ADDENDUM NO. 5

7/13/2021

TA-PM-2022-001

Philipse Manor Hall State Historic Site – Construction of Elevator/Restroom Addition, Interior and Exterior Rehabilitation and Site Enhancements

Sheet Title: **MANOR AND ADDITION FIRST FLOOR PLAN**
 Drawing Number: **A101**
 Bid Documents
 Project Number: **18006.47**

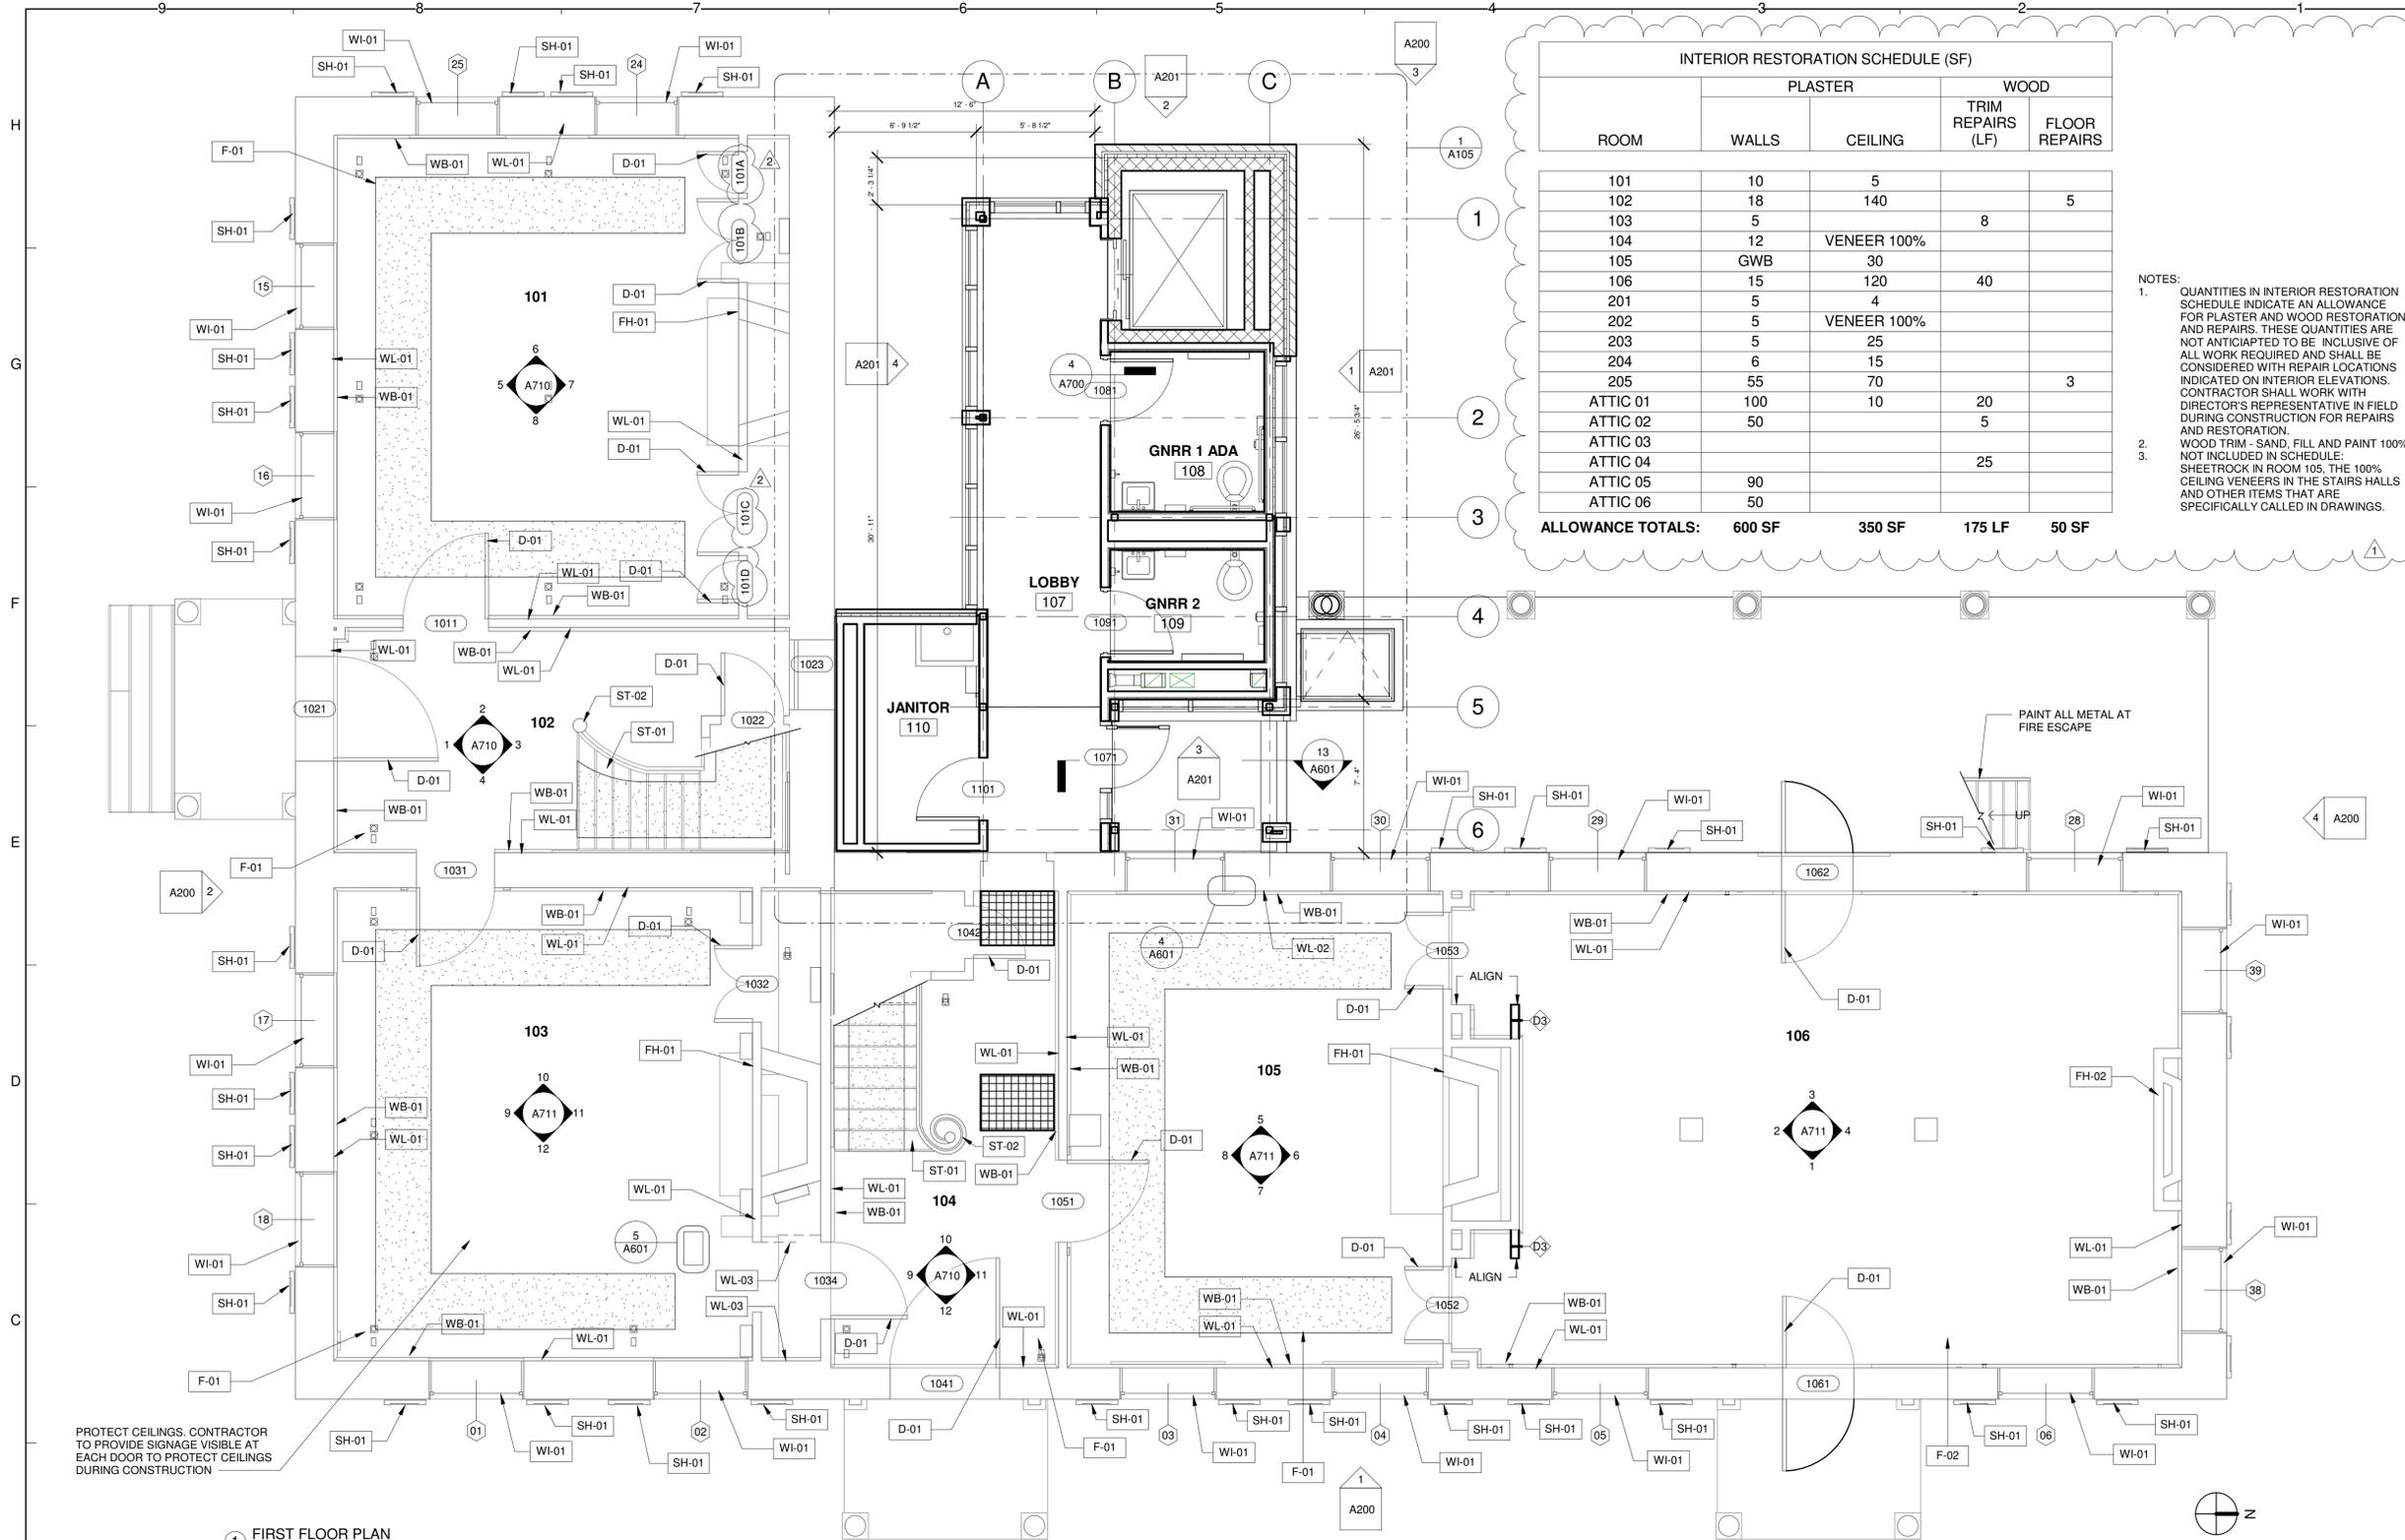
Q10. The door schedule shows Doors 101A, 101B, 101C, 101D, 203A, and 203B that cannot be located on the plans. Where are these doors?

Q16. *Wood Floor Restoration Spec 09640-2.1 calls for new wood flooring to replace existing where damaged at Room 205 "as indicated on drawings". The drawings do not seem to indicate where the flooring is damaged. Please provide extent of damaged areas that need replacing.*

Q17. *Wood Floor Restoration Spec 09640-3.1.A indicates that areas have been identified for replacement of existing wood flooring, but neither the floor finish schedule, nor the floor plans seem to show the extent of this replacement. Please identify extent of replacements, and whether the softwood or hardwood floor is required in each location.*

Q18. *Spec 09640-3.1.B indicates removal of deteriorated flooring, but the floor finish schedule, nor the plans seem to show the extent and location of deteriorated flooring, and removal of flooring is not indicated anywhere on the drawings (except Room 203). Please clarify extent and location of deteriorated flooring, and which type of wood floor goes back in its place (softwood or hardwood).*

- a. **Response: Refer to revised plans A101 and A102. Doors 101A-101D are located in the cabinetry in room 101. Doors 203A and 203B are in the small space between rooms 203 and 204.**

- a. **Response: Refer to revised Sheet A101 for damaged wood flooring to be replaced in Room 104.**

- a. **Response: Wood flooring shall be replaced via the ramp near door 2051 as shown on A102. Refer to detail 14/A601 for extent of work at ramp. Wood flooring infill shall be provided at the entrance to the addition in Room 205. Refer to revised sheet A102 for allowance of floor replacement at Room 205. Refer to revised sheet A101 for extent of wood flooring replacement in Room 104.**

- a. **Response: Refer to revised sheet A101 and revised specification 09 64 20 Wood Flooring Restoration.**

Sheet Title: **DETAILS**

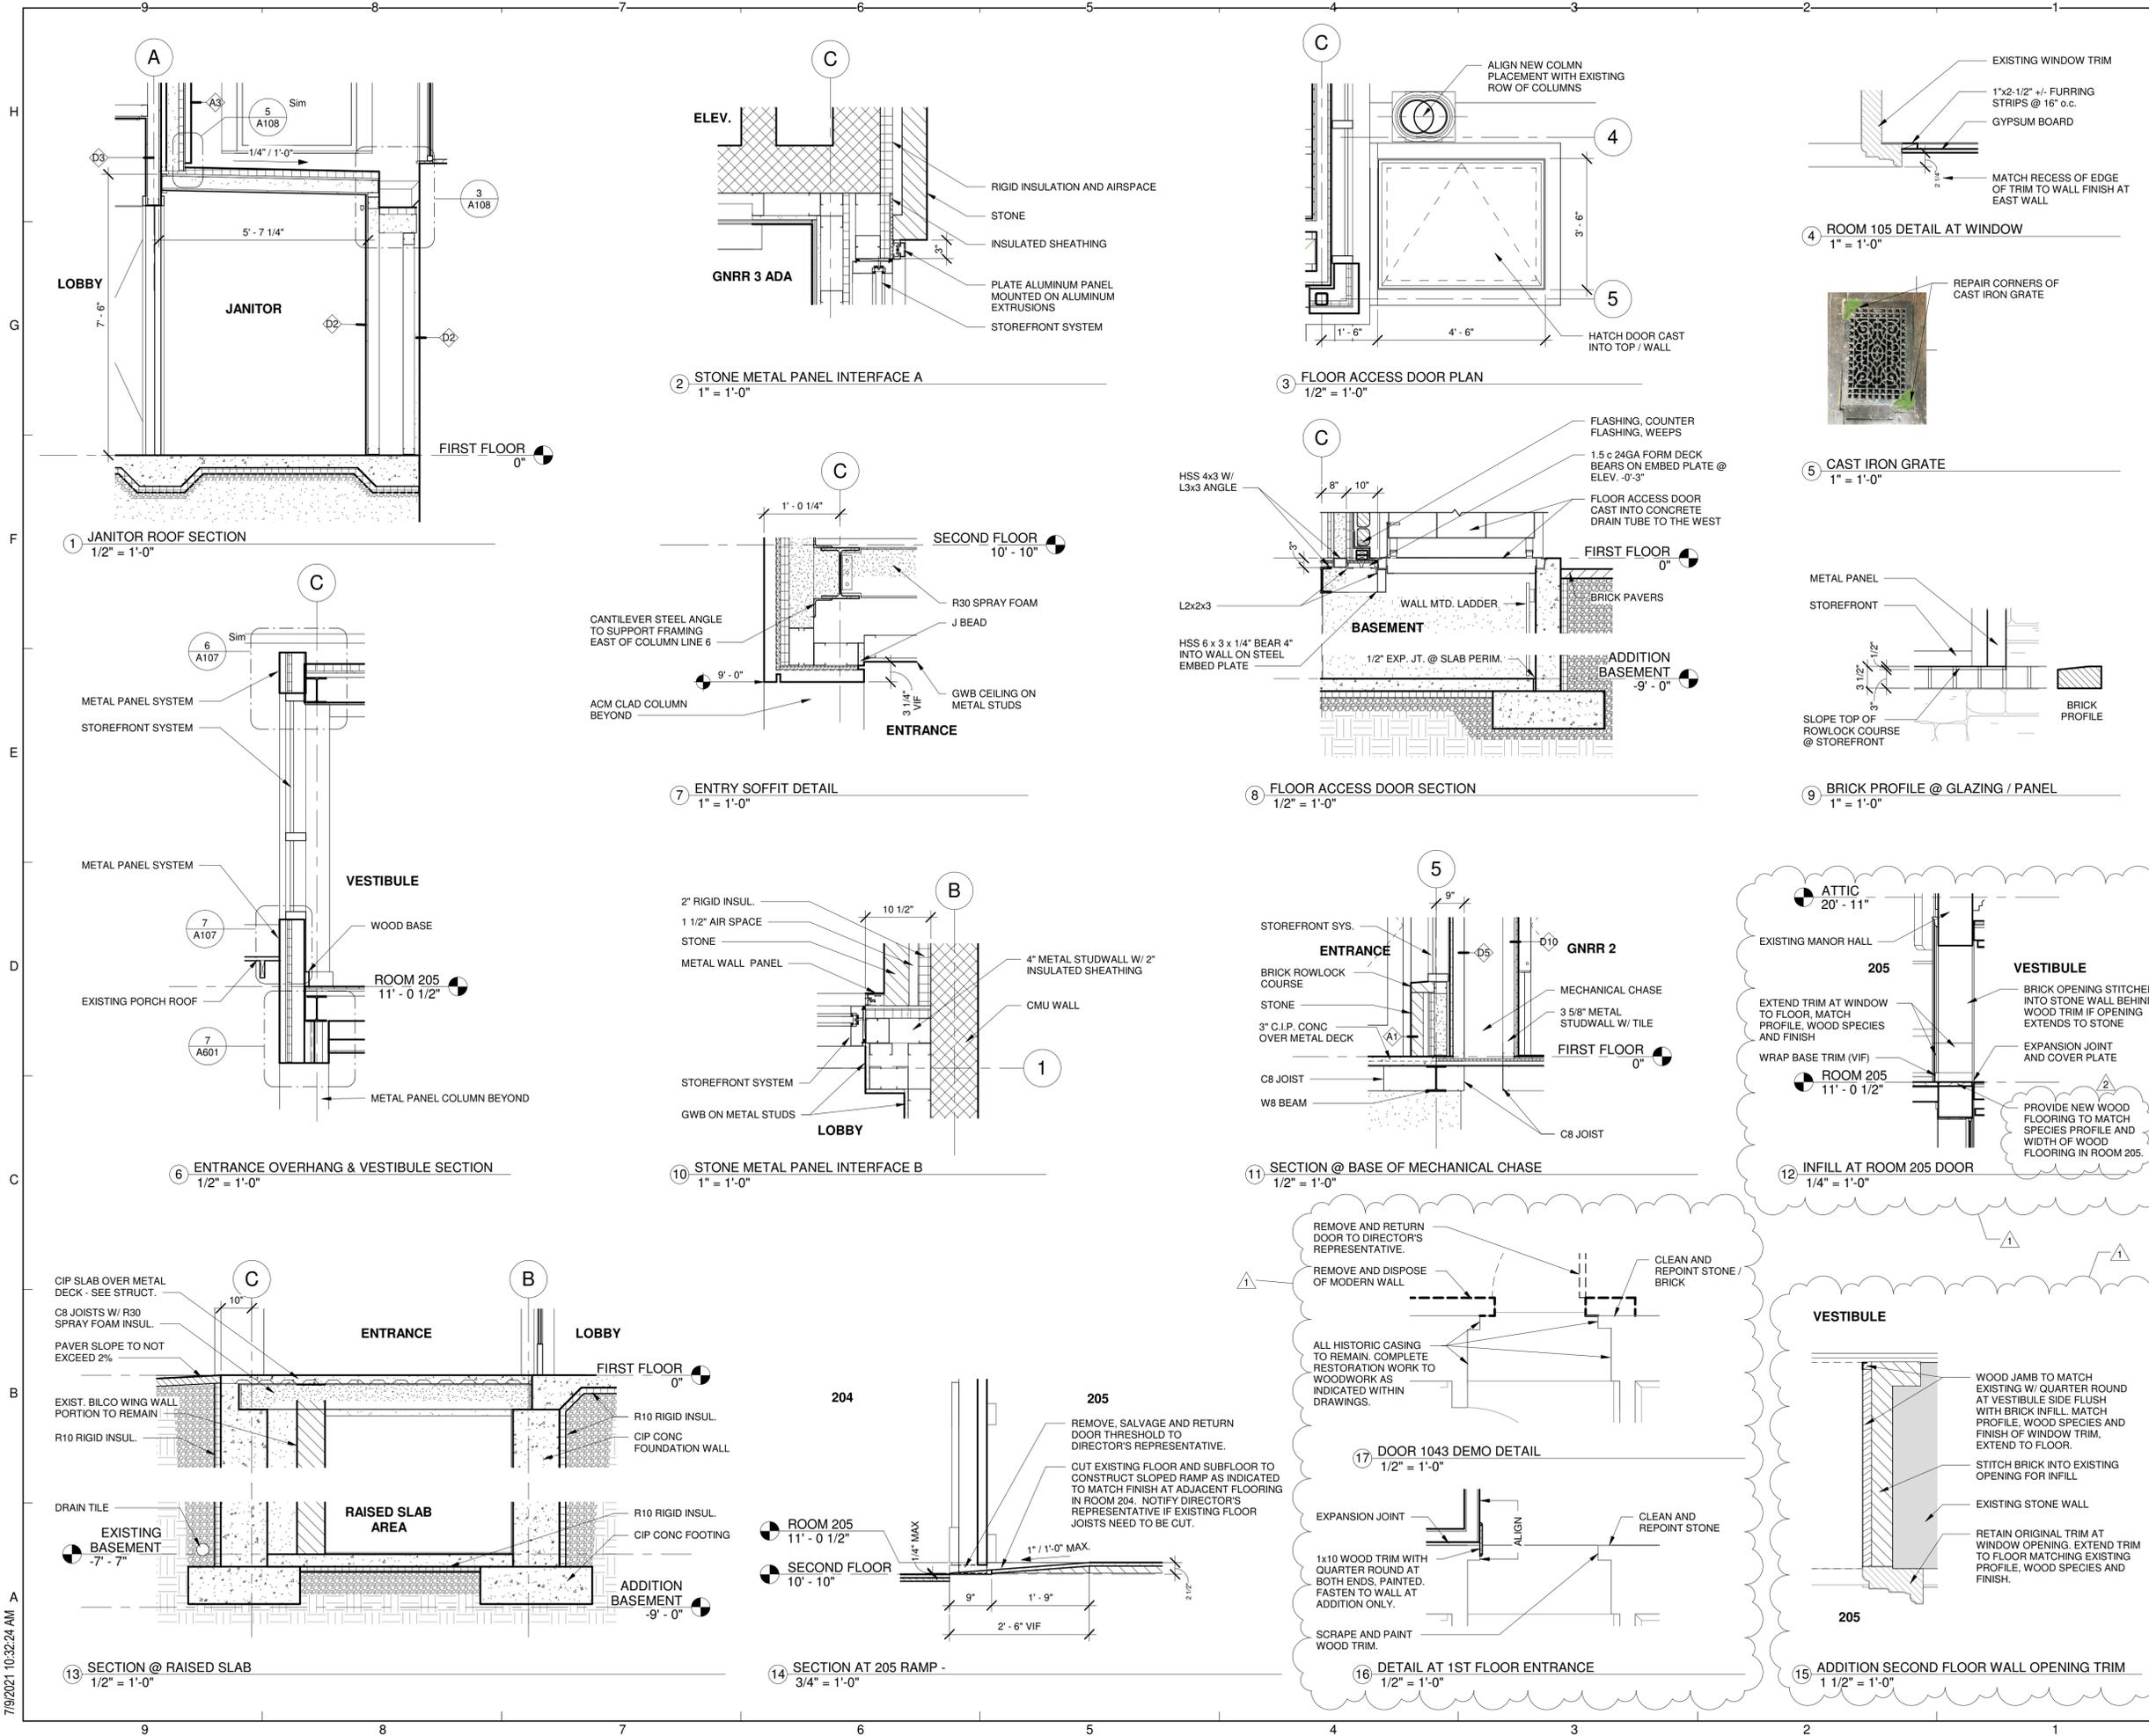
Q3. There is no information on the drawings regarding the new column shown on 3/A601 and Elevation 1/A201. Please provide spec.

- a. **Response: This is not a new column, it is a relocated column. Refer to A010, "Remove column and footing – Relocated to new position during reconstruction."**
